245 kV CAPACITOR VOLTAGE TRANSFORMER TYPE: CPB-H 245

END CUSTOMER:
APTRANSCO

**CHIEF ENGINEER
PLANNING & POWER SYSTEMS
APTRANSCO**

LIST OF DOCUMENTS FOR CPB-H 245 TYPE CVT

General Arrangement Drawing

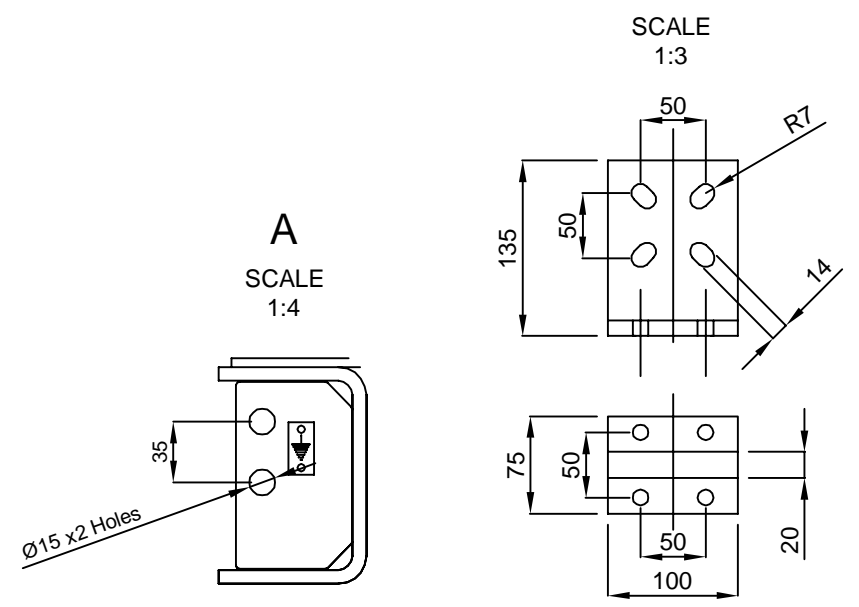
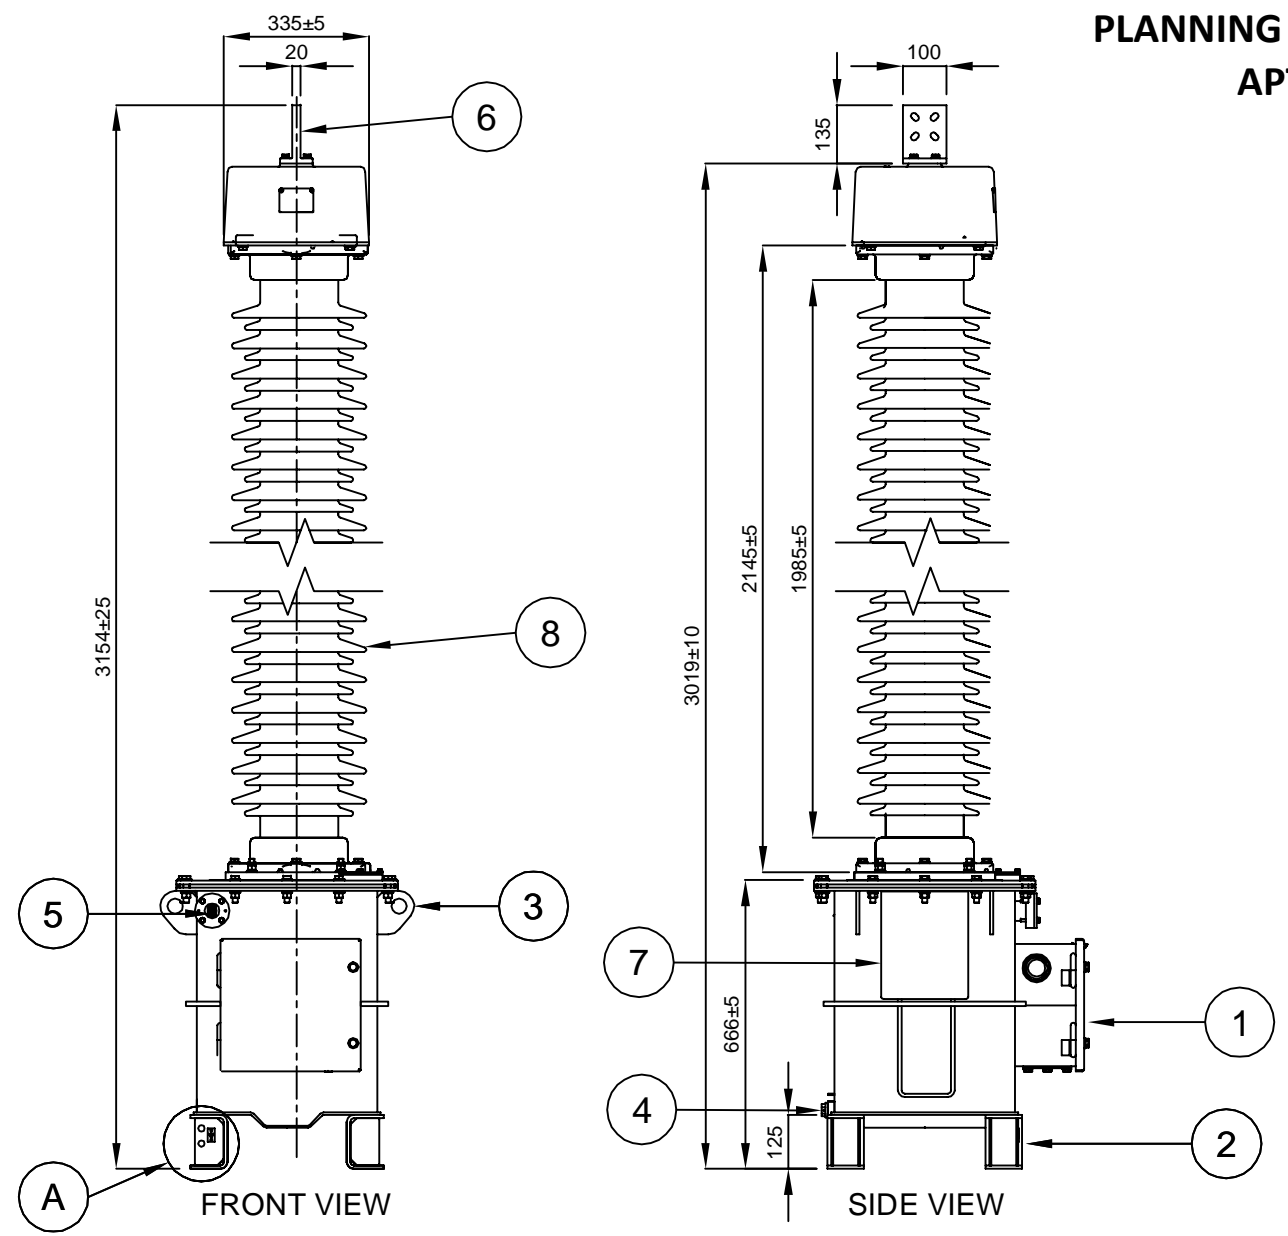
NOTE: 1. DRAWING APPROVAL SUBJECT TO VALID TYPE TEST REPORTS, TO BE CHECKED DURING ACCEPTANCE TESTS
2. FOR EPC CONTRACTS ONLY

Drawing approval subject to valid vendor registration

- Minimum 300mm plinth shall be maintained for CT/PT/CVT/Isolators/IV/LA/Breakers in the Substation during foundation works to ensure safe live to ground clearance as per IE rules.
- Since the supply of terminal connectors is not in the scope of manufacturer as mentioned in the drawings. The EPC contractor shall be instructed to supply the same in line with CT/PT/CVT/Isolator/IVT/LA/Breakers requirement and compatibility.

Revision		Rating Plate: 1HYP000428P3		Rating & Diagram Plate for 245kV Capacitor Voltage Transformer		DRAWN: SR	CHECKED: SNP	APPRD.: SN	file :3320-058	TOTAL SH. 1
A	2022-06-09					HITACHI ENERGY INDIA LIMITED (FORMERLY KNOWN AS APPSIL)		1HYT903320-058		Sh. NO. 1
B	2022-06-28

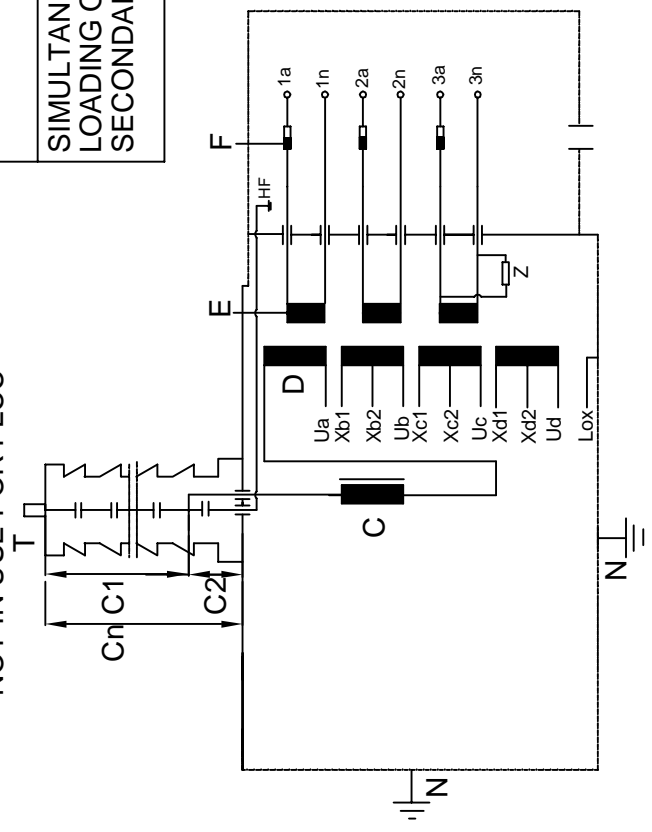
NOTE: 1. DRAWING APPROVAL SUBJECT TO VALID TYPE TEST REPORTS, TO BE CHECKED DURING ACCEPTANCE TESTS
2. FOR EPC CONTRACTS ONLY

Drawing approval subject to valid vendor registration

- Minimum 300mm plinth shall be maintained for CT/PT/CVT/Isolators/IV/LA/Breakers in the Substation during foundation works to ensure safe live to ground clearance as per IE rules.
- Since the supply of terminal connectors is not in the scope of manufacturer as mentioned in the drawings. The EPC contractor shall be instructed to supply the same in line with CT/PT/CVT/Isolator/IVT/LA/Breakers requirement and compatibility.

Revision		245 KV Capacitor Voltage Transformer Type: CPB-H 245	SECONDARY TERMINAL BOX	DRAWN: SR	CHECKED: SNP	APPRD.: SN	file: 3320-059	TOTAL SH. 1
A	2022-06-09			HITACHI ENERGY INDIA LIMITED (FORMERLY KNOWN AS APPSIL)			1HYT903320-059	
B	2022-06-28

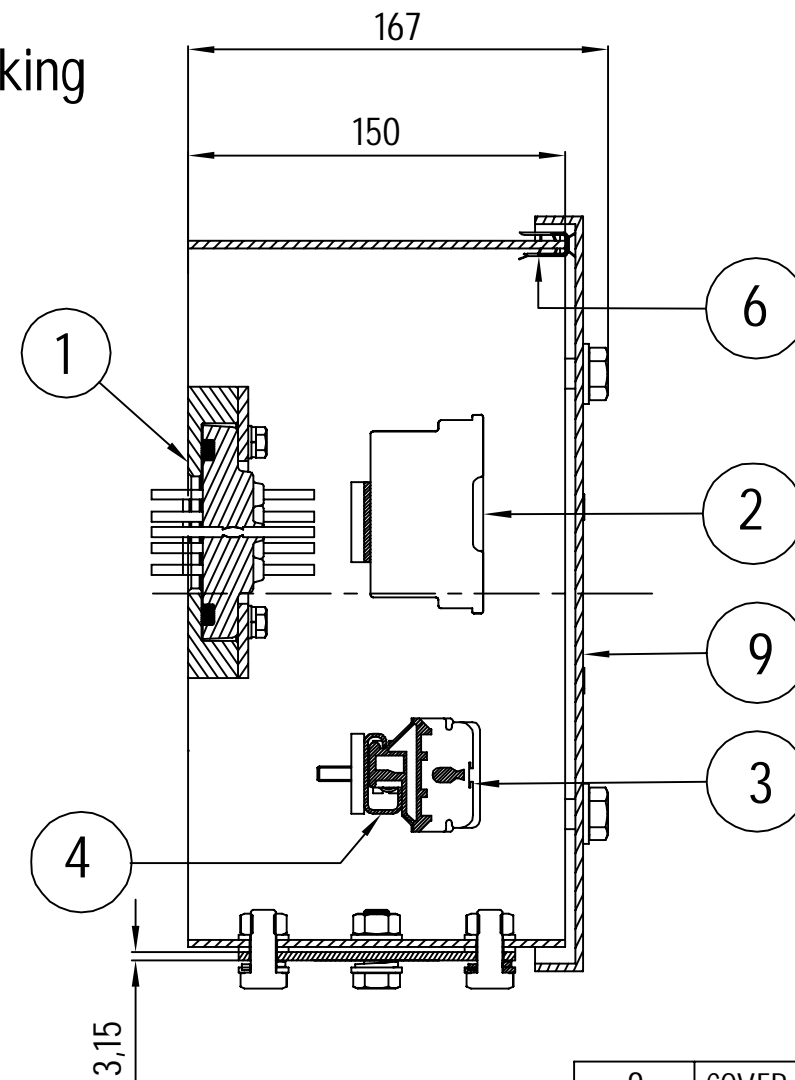
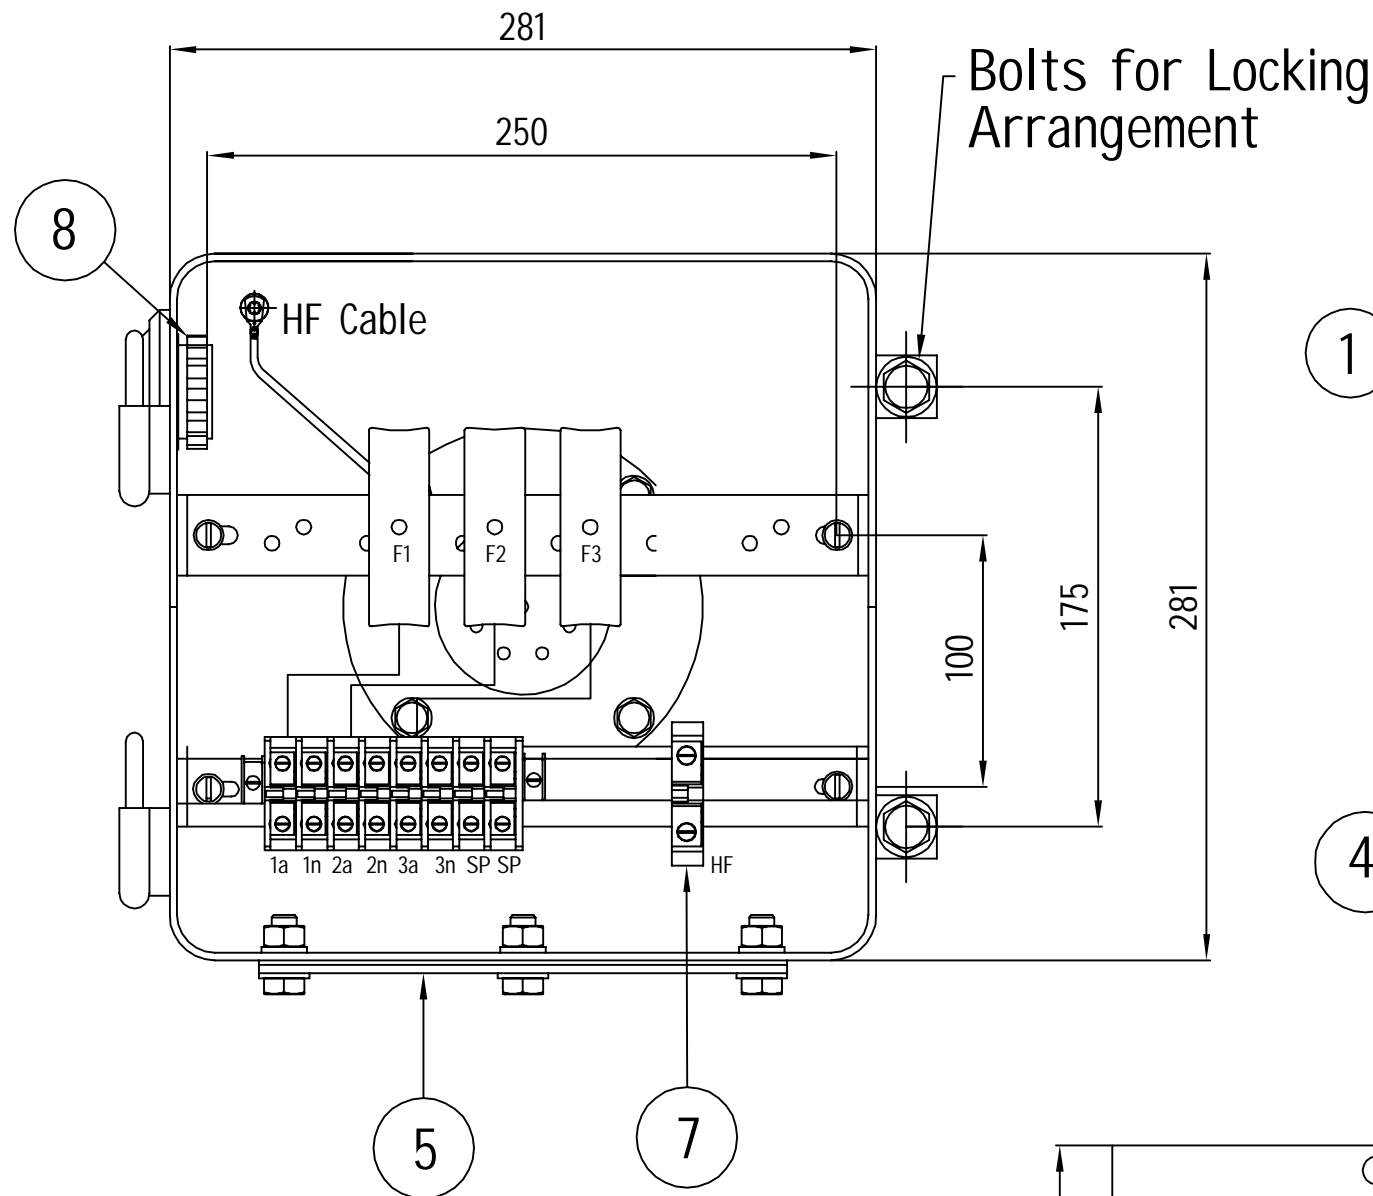
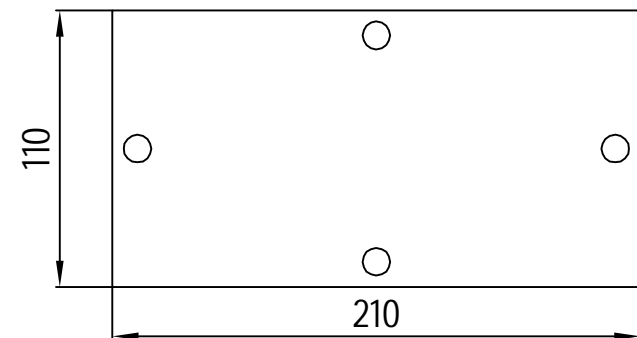
NOTE: 1. DRAWING APPROVAL SUBJECT TO VALID TYPE TEST REPORTS, TO BE CHECKED DURING ACCEPTANCE TESTS
2. FOR EPC CONTRACTS ONLY

1. Minimum 300mm plinth shall be maintained for CT/PT/CVT/Isolators/IV/LA/Breakers in the Substation during foundation works to ensure safe live to ground clearance as per IE rules.
2. Since the supply of terminal connectors is not in the scope of manufacturer as mentioned in the drawings. The EPC contractor shall be instructed to supply the same in line with CT/PT/CVT/Isolator/IVT/LA/Breakers requirement and compatibility.

Drawing approval subject to valid vendor registration

Revision		245 KV Capacitor Voltage Transformer Type: CPB-H 245	SECTIONAL VIEW	DRAWN: SR	CHECKED: SNP	APPRD.: SN	file: 3320-060	TOTAL SH. 1
A	2022-06-09			HITACHI ENERGY INDIA LIMITED (FORMERLY KNOWN AS APPSIL)			1HYT903320-060	Sh. NO. 1

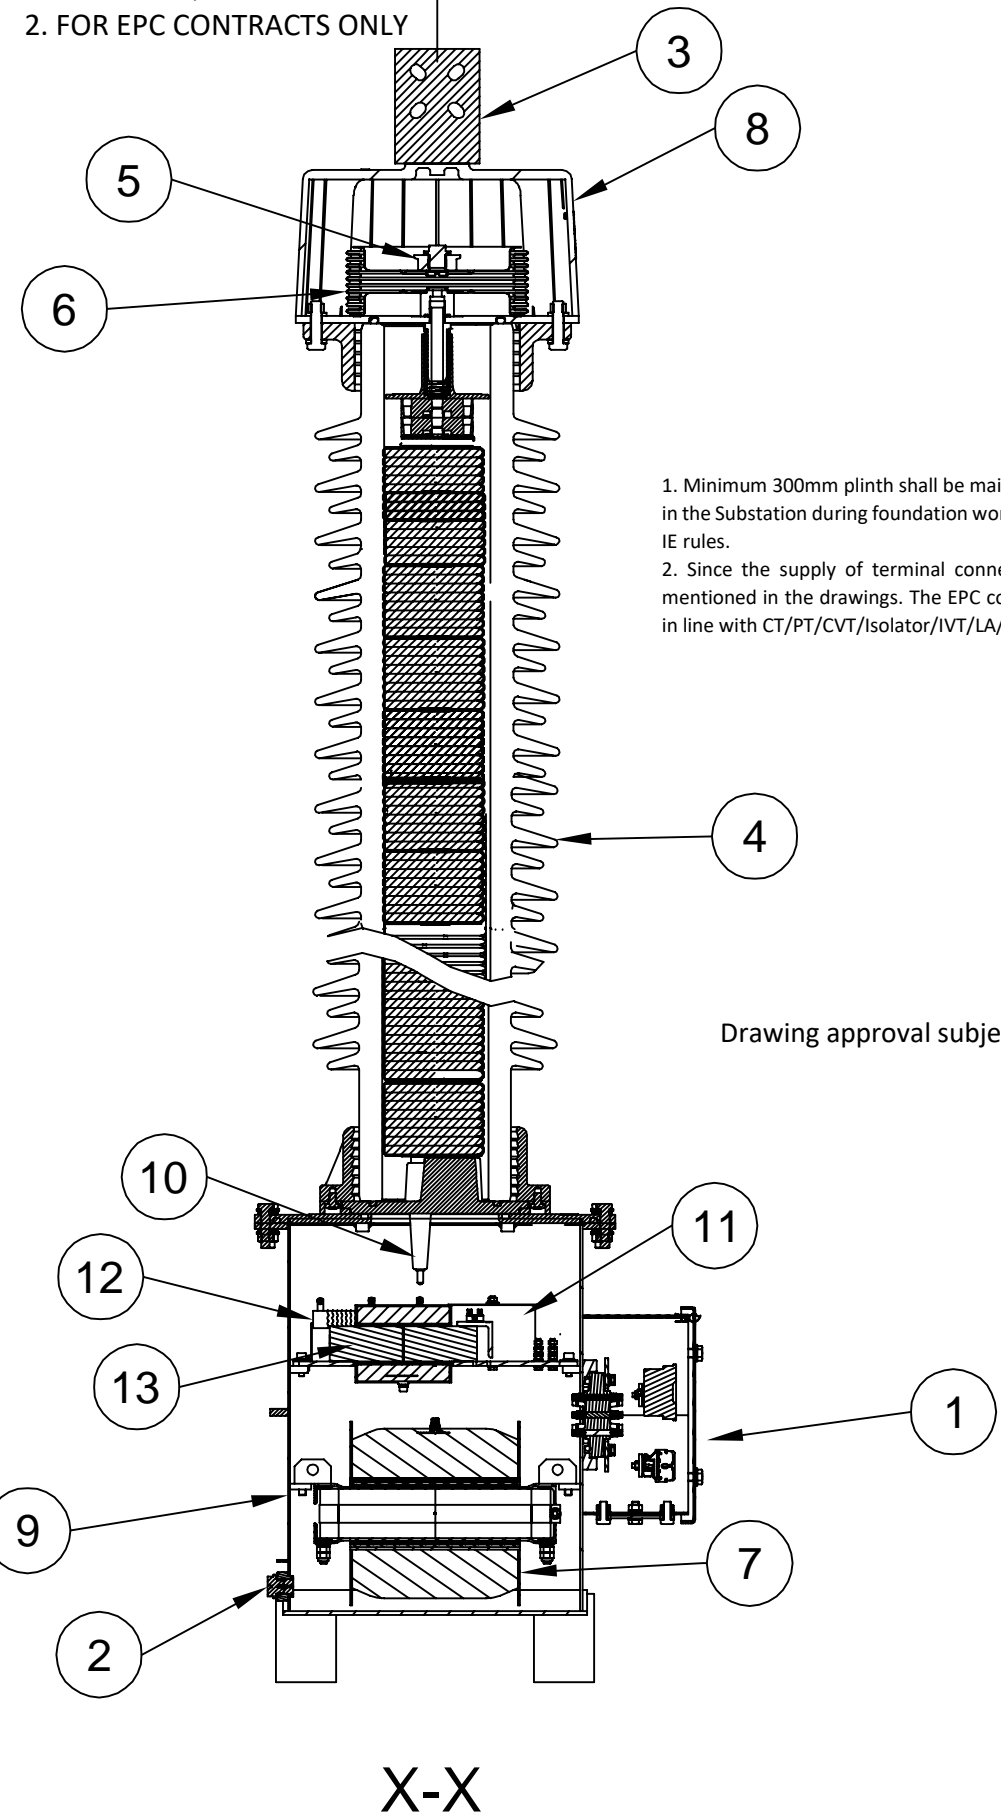
NOTE: 1. DRAWING APPROVAL SUBJECT TO VALID TYPE TEST REPORTS, TO BE CHECKED DURING ACCEPTANCE TESTS
2. FOR EPC CONTRACTS ONLY

1. Minimum 300mm plinth shall be maintained for CT/PT/CVT/Isolators/IV/LA/Breakers in the Substation during foundation works to ensure safe live to ground clearance as per IE rules.
2. Since the supply of terminal connectors is not in the scope of manufacturer as mentioned in the drawings. The EPC contractor shall be instructed to supply the same in line with CT/PT/CVT/Isolator/IVT/LA/Breakers requirement and compatibility.

Drawing approval subject to valid vendor registration
